Borumba Pumped Hydro Energy Storage proposal

MRCCC submission to Qld Hydro, on the Exploratory Works, draft Preliminary Documentation

5.5 Potential cumulative impacts – RFI item 4.5(b)

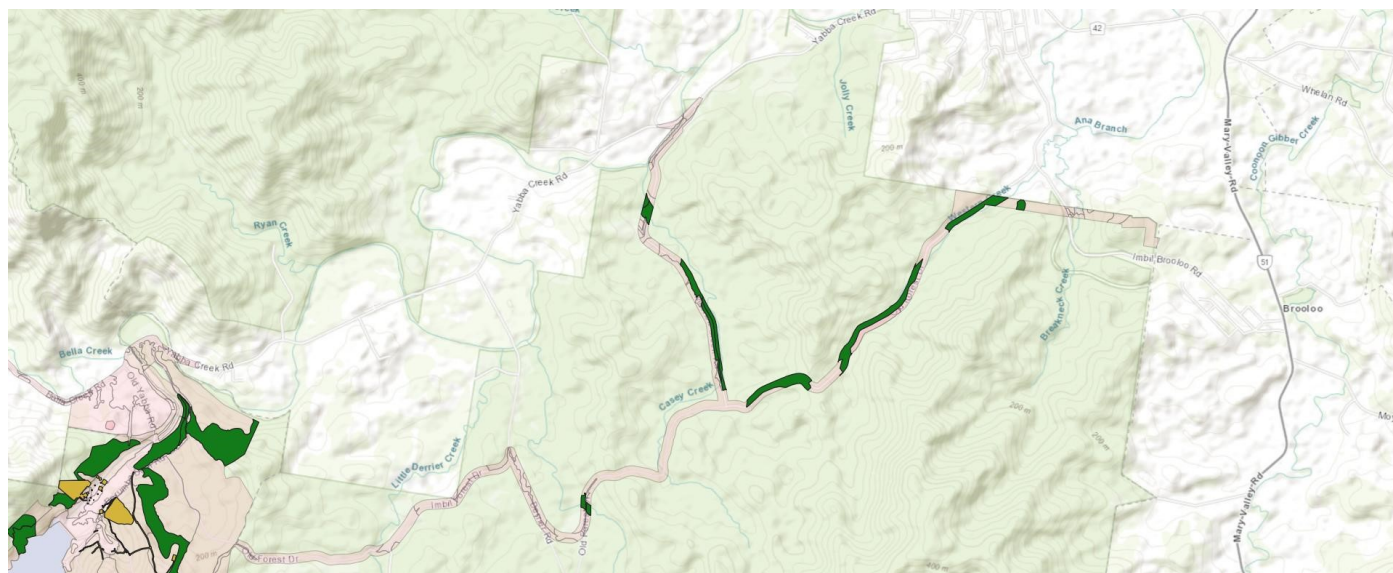
There are many large-scale renewable energy projects in the vicinity of the Borumba project that may or may not have significant impacts on MNES. However, they contribute to the general cumulative impact of the wider changes being planned for the local power grid, of which Borumba is only one component. If the exploratory works for Borumba were not to proceed, the wider impacts of most of these other proposals would still occur, given that the energy storage and grid services required would be provided by means other than Borumba.

The major exception is the Powerlink project for two power line connections from the Borumba site to Halys and Woolooga substations. The Powerlink project will have major impacts on MNES, and its impacts should not be assessed separately from the Borumba exploratory works and main works, as all three referrals are integrally interconnected parts of the same project, artificially divided into separate assessments.

At a smaller scale, there are several actions currently underway or being planned in the Mary River catchment with the specific purpose of enabling the exploratory works for Borumba to proceed, which have not been referred for assessment under the EPBC Act.

These actions will have impacts on the same controlling provisions being assessed for the Borumba exploratory works— namely threatened ecological communities and threatened species. Considered individually, these actions may or may not have significant residual impacts, but because they would not be taking place if the Borumba exploratory works were not proceeding, their impacts should be considered as cumulative impacts of the exploratory works. These actions will also benefit the Borumba main works, but it can be argued that as they are being built and planned now for the exploratory works, their impact and any offset requirement should be assessed as part of the exploratory works referral.

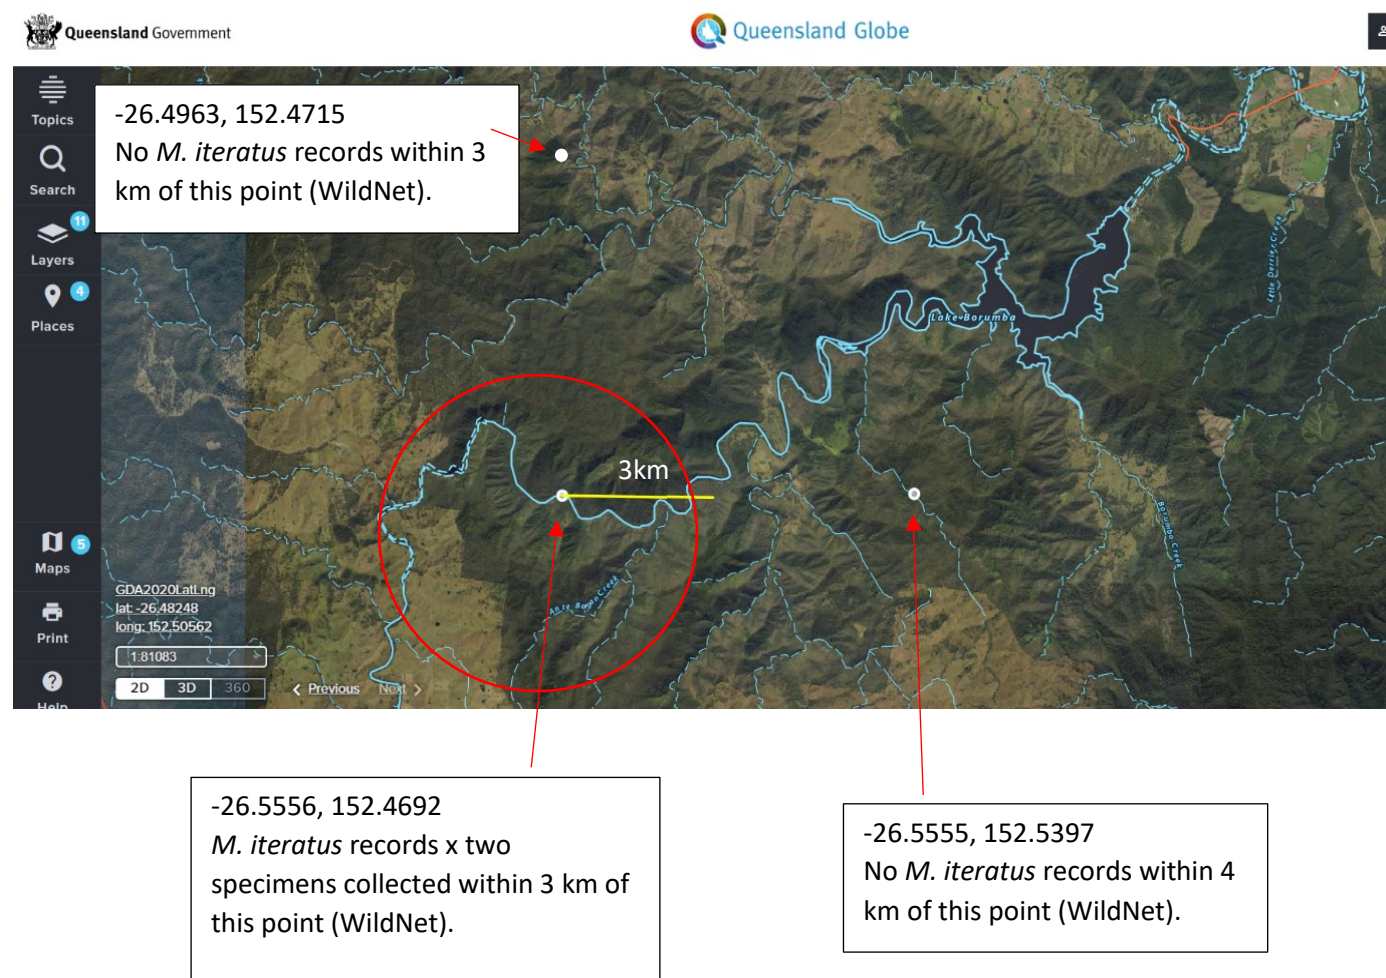
- Survey effort
 - Amphibian targeted surveys only between 11 to 21 December 2022 at only seven sites. While 2022 is remembered as a very wet year in the Mary River catchment, the last few months of 2022 were drier than usual. December 2022 mean rainfall for Upper Kandanga (Oakwood rainfall station) is 124mm, however December 2022 only recorded 73mm; therefore conditions may not have been conducive for Giant barred frog acoustic detection.
 - No mention of effort for targeted amphibian surveys.
 - Where are the seven amphibian targeted survey sites?
 - Call playback was only for one hour during each of the periods 5th to 9th December 2024 and 5th to 9th February 2025. Not very long periods. How many sites?

Unfortunately February 2025 was not a good survey period with below average rainfall conditions according to the Oakwood rainfall station. MRCCC frog surveys in February 2025 were not as successful compared to other wetter years. December conditions? No description of conditions conducive for *M. iteratus* activity and calling. More information is required.
